SUBJECT: Installation of Hanlon & Wilson Exhaust System

MODELS AFFECTED: M-20A, Serial Numbers 1201 thru 1700A

This Service Letter reidentified as
Service Bulletin M-20-91
per Service Instruction M20-15.

FIGURE 1

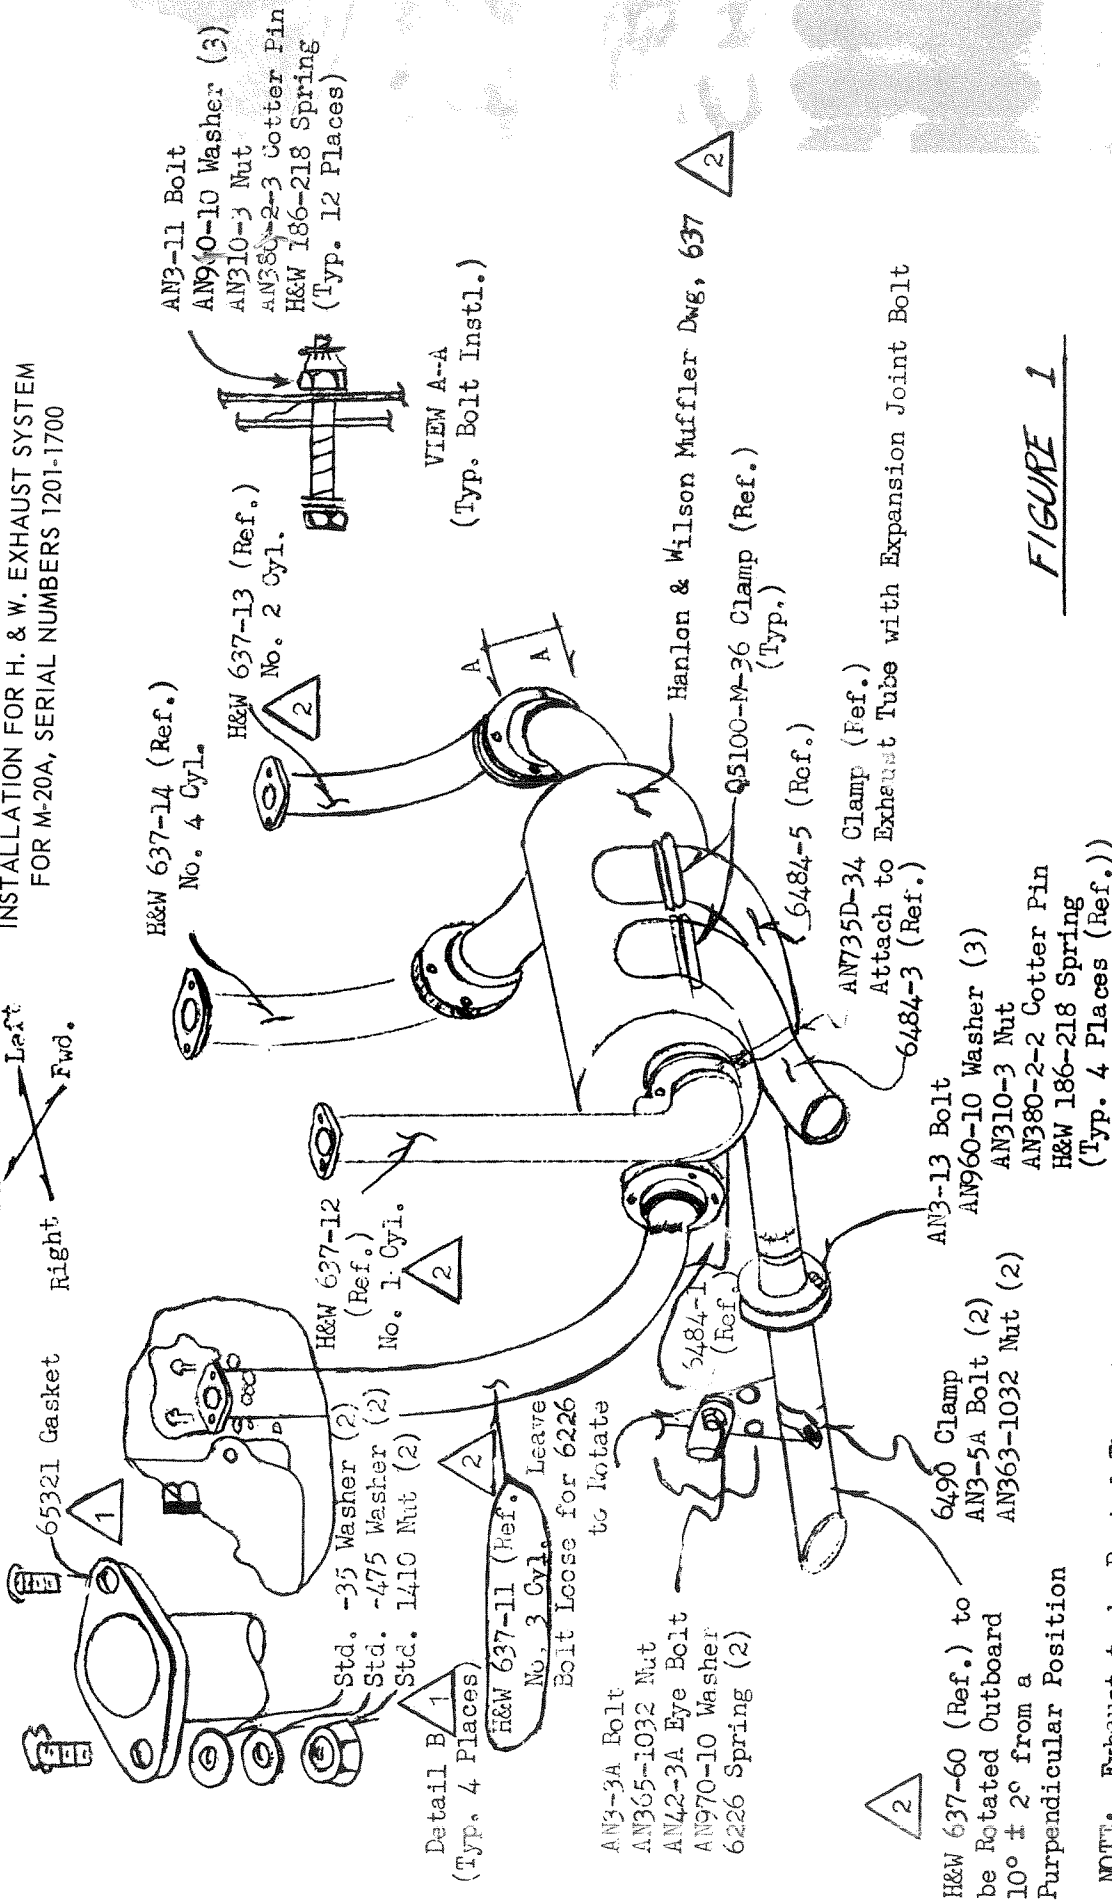
- b. Install Hanlon & Wilson No. 637 Muffler Assembly.
 - c. Hanlon & Wilson No. 637-11, -12, -13, & -14 exhaust extensions on cylinders as shown in Figure 1, Detail B. Leave the nuts attaching extensions very loose at this time.

- d. Install exhaust extensions on muffler assembly as shown in Figure 1, View A-A. Nuts should be installed on the bolts only far enough so that the cotter pins may be installed. DO NOT TIGHTEN THE NUTS.

- e. Shake muffler assembly slightly to seat the exhaust extensions to the muffler and tighten nuts attaching exhaust tubes to cylinders to 110-150 inch/pounds torque.

- f. Install Hanlon & Wilson No. 637-60 tail pipe as shown in Figure 1.
 - g. Attach 6484-5 duct to heater and 6504-1 elbow. Rotate elbow on carburetor air box to obtain 1/4" to 1/2" clearance between 6484-5 and 6179 air intake duct. Tighten clamp and install screw to secure P/N 6504-1 elbow.

FIGURE 2

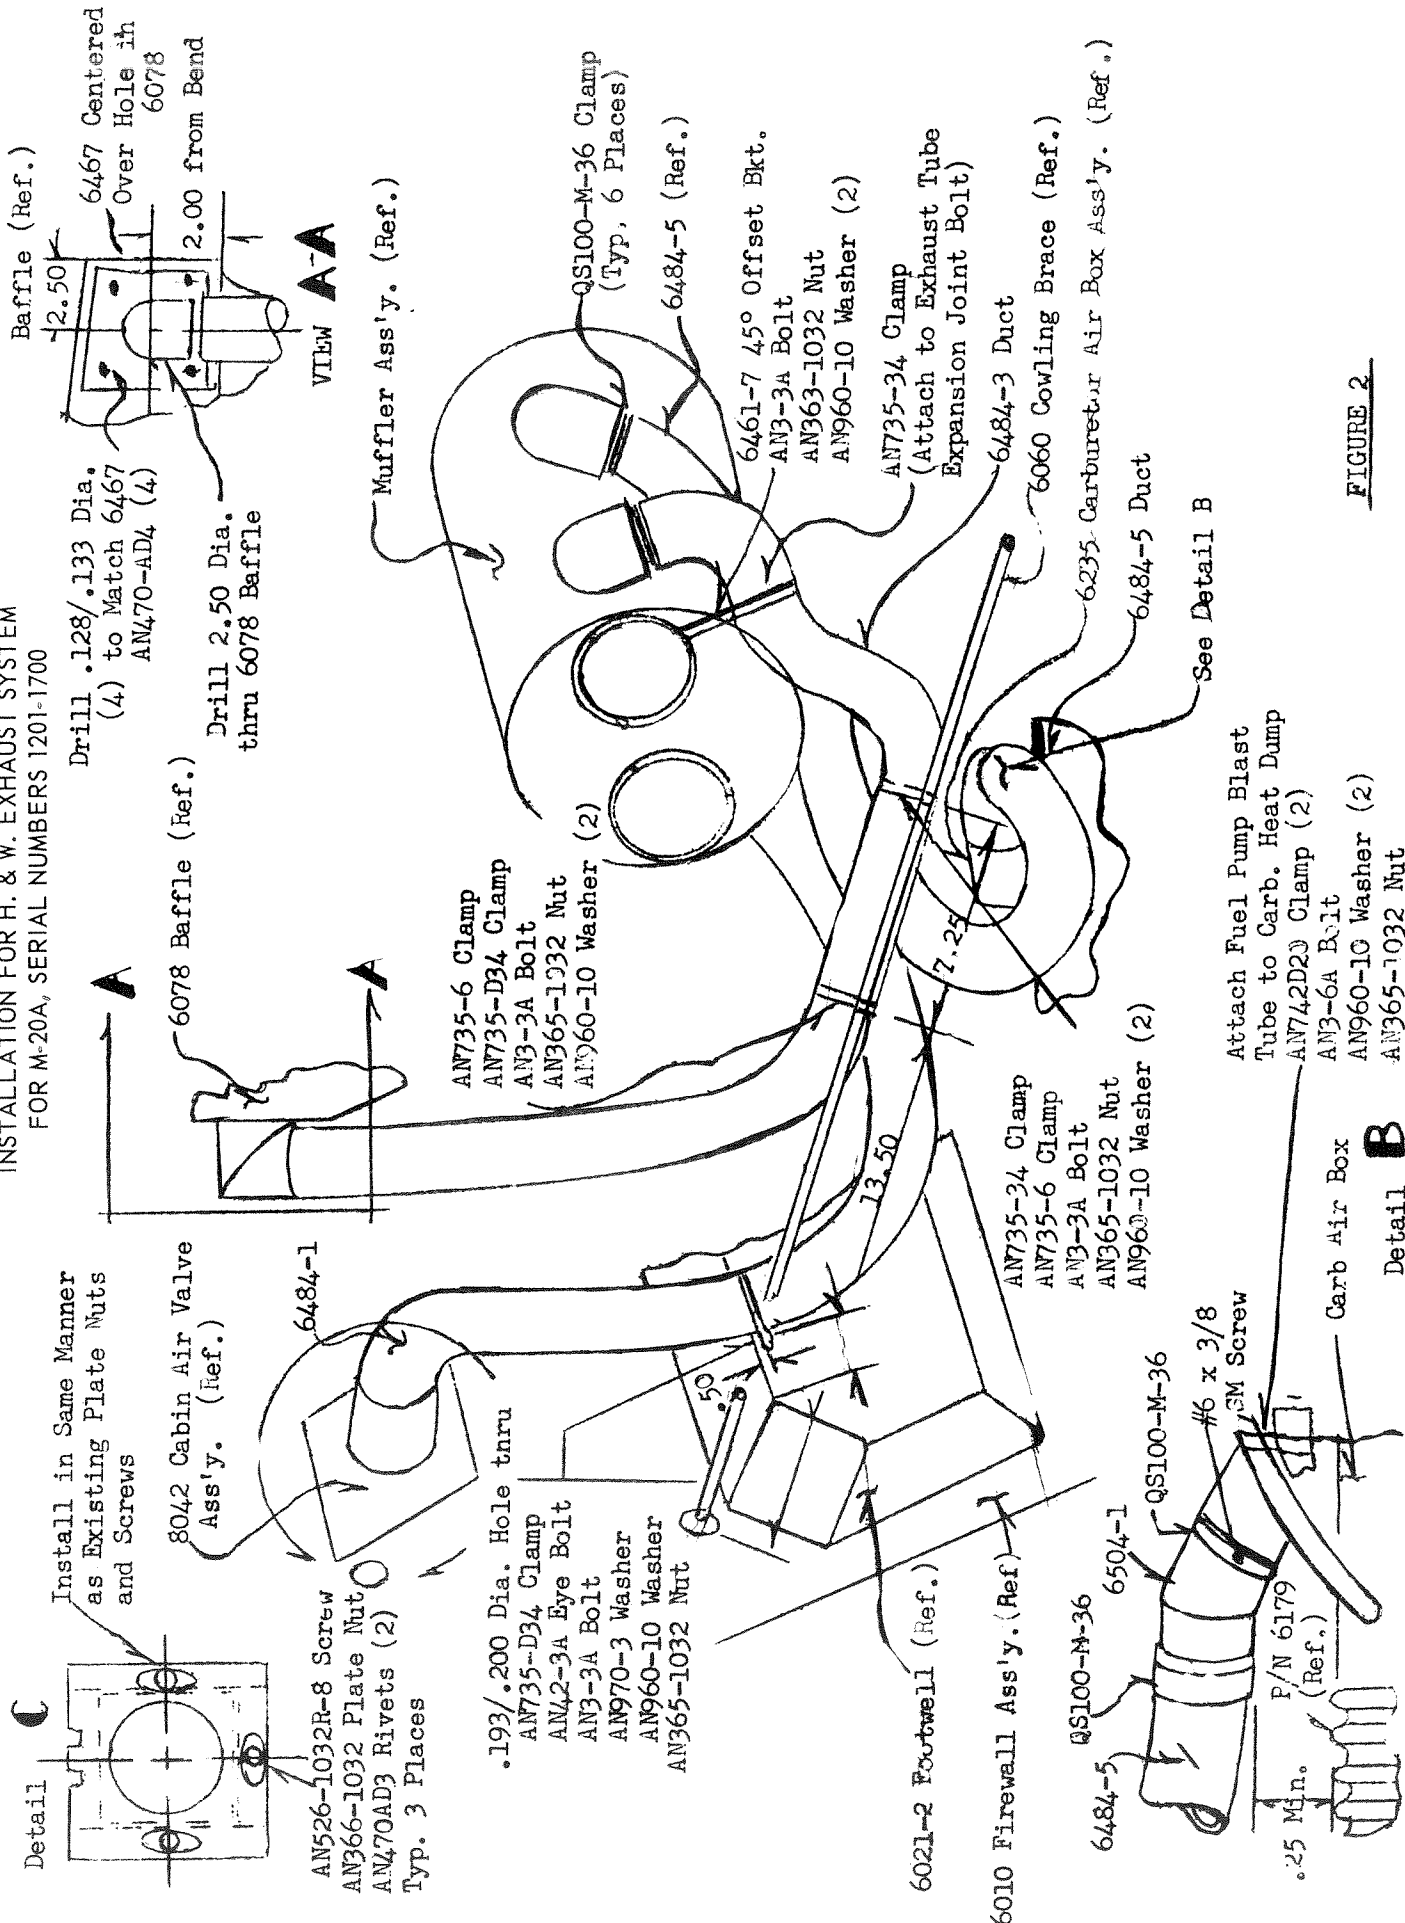
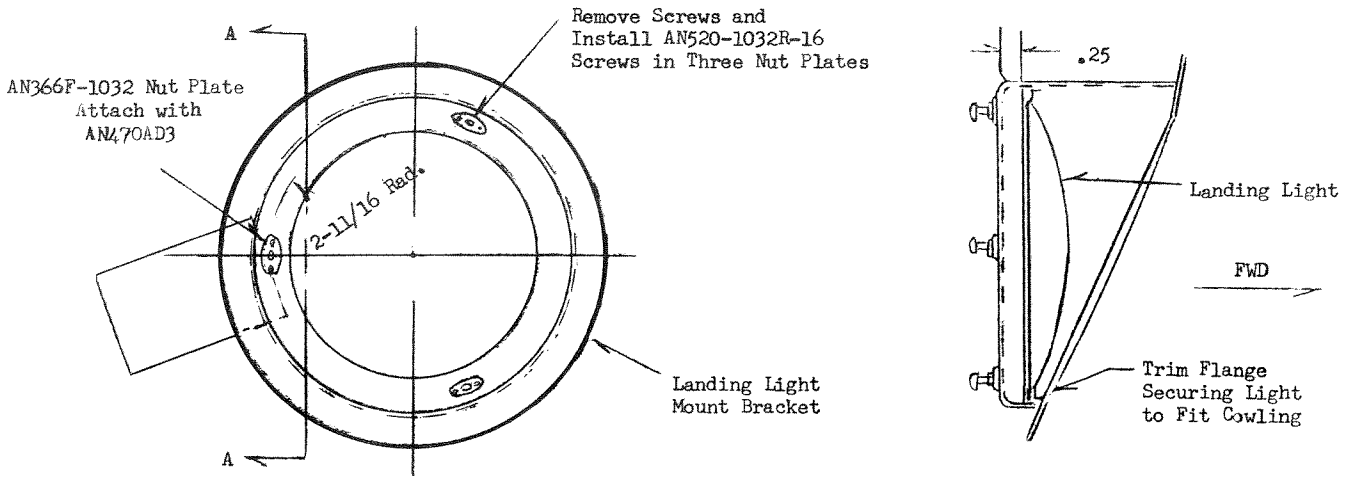
3. Rework the cabin heat valve as shown in Figure 2, Detail C.
4. Rework the landing light bracket as shown in Figure 3.
5. Install the oil cooler bracket (P/N 6469) in place of the old oil cooler bracket. Use AN470AD4 rivets to attach the bracket to the cowling.

8. Install the following equipment in the sequence listed below:
 - a. Install P/N 6504-1 on carburetor air box as shown in Figure 2, Detail B. DO NOT tighten clamp or install screw at this time.

- h. Install P/N 6467 alternate air source tube as shown in Figure 2, View A-A.
 - i. Re-install P/N 6060 cowl brace at firewall attachment.
 - j. Install P/N 6484-1 & -3 ducts as shown in Figure 2.

FIGURE 3

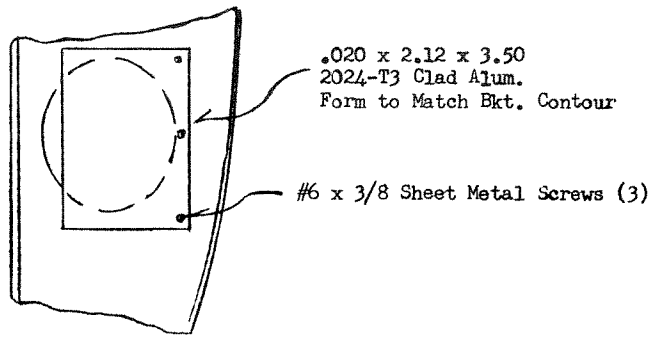
- k. Seal the original alternate air source inlet on the landing light bracket as shown in Figure 3, View A-A.
 - l. Install landing light as shown in Figure 3.
